Memorandum

Date: April 24, 2025	
To: Brian Froelich, AICP	Organization: City of Capitola
From: RRM Design Group	Title: Design Review Team
Project Name: Capitola On-Call Architectural and Landscape Review	Project Number: 1783-09-PP25
Topic: 506 Pine Street Review

Site Plan

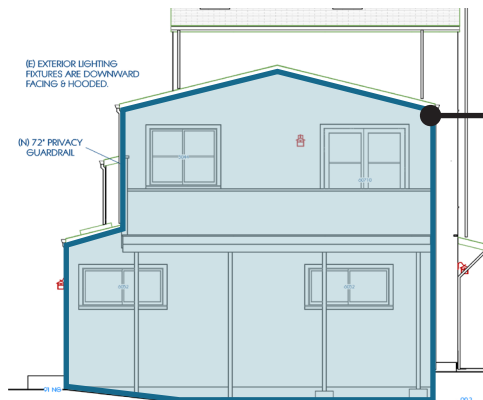
The applicant should remove guest parking spaces from the plans as the proposed locations will cause ingress and egress issues for residents needing to access the detached unit/duplex garages.

Revise the site plan to include pedestrians walkways connecting the public realm and proposed primary entries to provide safe connections for residents and guests.

1. Revise the site plan to create a pedestrian connection from the existing duplex and proposed detached unit primary entries to the public realm to allow for safe passage for residents and guests (OS 17.82.060.C.1).

Response: Discussion with previous planner indicated that pedestrian walkway could be on right side in driveway with different coloring surface material TBD at construction documents. Exception requested for this item.

2. Remove the guest parking spaces as the inclusion of the guest parking spaces impacts the applicants ability to comply with OS 17.82.050.B.1 as parking spaces are not permitted to be located between a dwelling structure and front property line.

Response: Guest parking has been removed from all sheet as necessary .

Detached Unit South Elevation

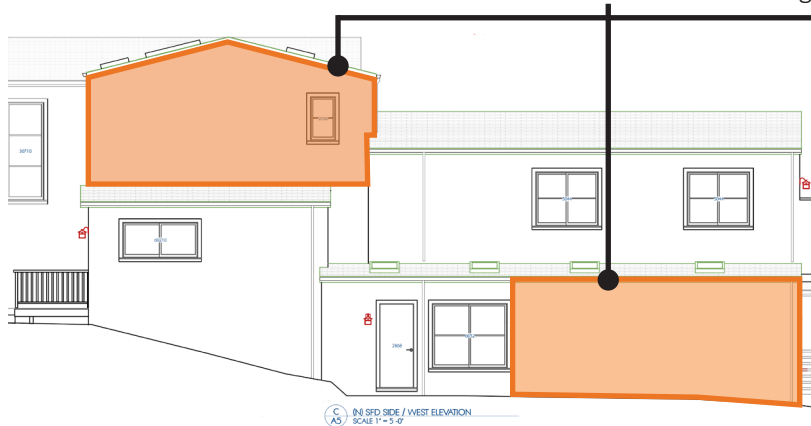
Incorporate a minimum of two façade design strategies per OS 17.82.080.B.3 in a manner consistent with the selected style. Potential solutions include introduction of an additional material on the ground floor similar to the wood paneling on the existing duplex, providing a porch, and/or any additional design intervention that improves the street facing elevation.

4. Incorporate two additional façade design strategies on the detached unit and duplex addition street facing elevations. This design intervention could come in the form of applying similar horizontal wood siding on the ground plane of the proposed detached unit/duplex addition or incorporating a front porch (OS 17.82.080.B.3).

Response: stone has been added, please see sheets A7

Detached Unit West Elevation

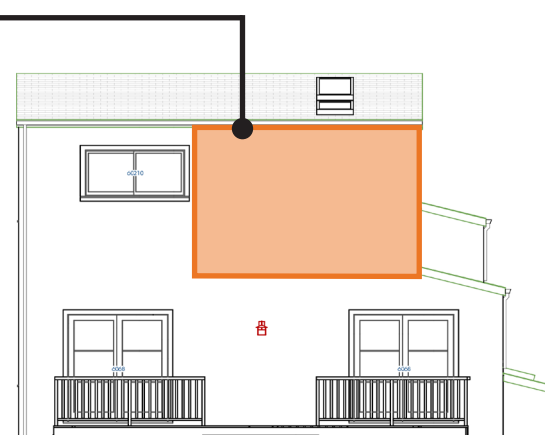
Revise the west and north elevations of the detached unit to remove large unarticulated blank wall space per OS 17.82.080.B.1.a. Potential solutions include additional windows, architectural detailing, variation in wall plane, and/or any design intervention that positively impacts the proposed detached unit street facing elevation.

3. Seek opportunities to modify the north and west elevations of the detached unit to remove blank wall space larger than 10 feet wide by 10 feet high through incorporating additional windows, architectural detailing, and/or any design intervention that adds interest to the elevation (OS 17.82.080.B.1).

Response: stone has been added, windows realigned and added please see sheets A5

Existing Duplex On-Site

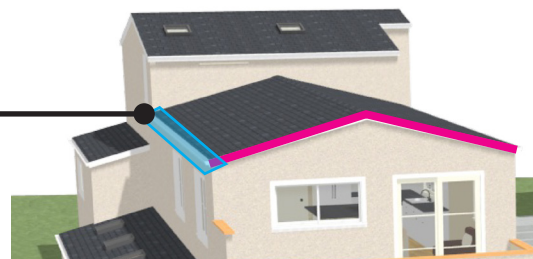
Applicant should match the pitch of the detached unit and duplex addition to the existing duplex. Similarly, utilize the same eave overhang shown on the existing duplex on the proposed detached unit as this design feature is consistent with the selected California Ranch architectural style.

5. Utilize the same roof pitch used on the existing duplex on the proposed detached unit to ensure consistency with the intended architectural style and establish consistency with existing structure on-site.

Response: Pitches are the same- please see sheet A5 & A7

6. Ensure the existing duplex eave overhang design feature extended from the exterior walls is carried over to the proposed detached unit to solidify consistency with both the existing on-site structure and architectural style.

Response: Eaves have been updated - see sheet A5

Detached Unit Street Facing Elevation

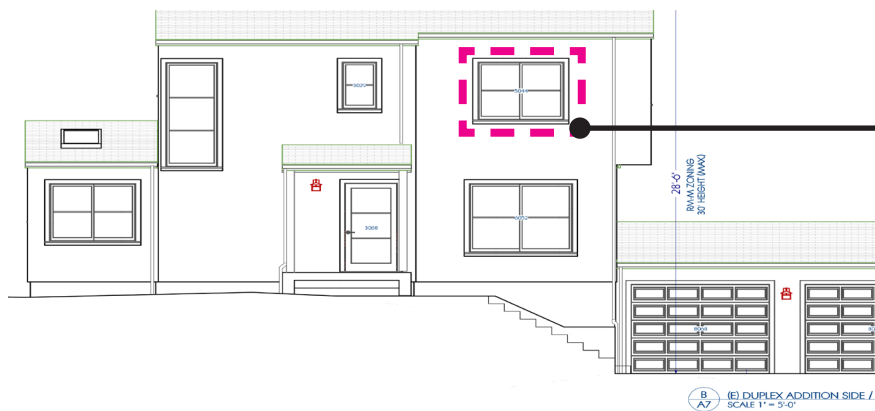
Revise window location to avoid being located on a wall line.

Existing Duplex Addition West Elevation

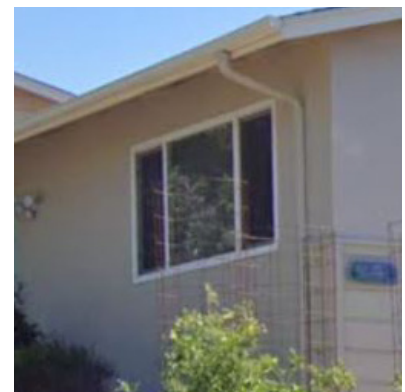
Look for opportunities to utilize sliding window style used on the existing duplex elsewhere on the proposed project as the window style is consistent with the California Ranch architectural style.

10. Seek opportunities to utilize the sliding window style used on the existing duplex elsewhere on the project, including the detached unit and duplex addition.

Response: Sliding window styles used on front-facing windows - See sheet A5 and A7

Detached Unit West Elevation

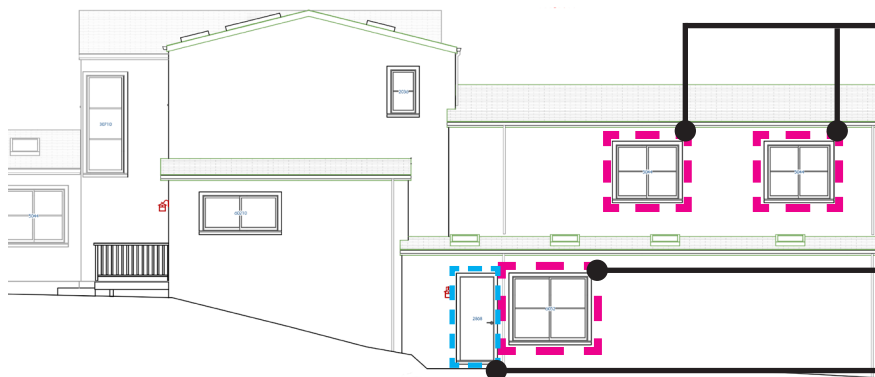
Provide landing to remove appearance of floating door and avoid future safety issues.

13. Provide a stepdown from the proposed doorway shown on the west elevation of the detached unit to avoid safety issues in the future.

Response: Elevation on A5 has been updated.
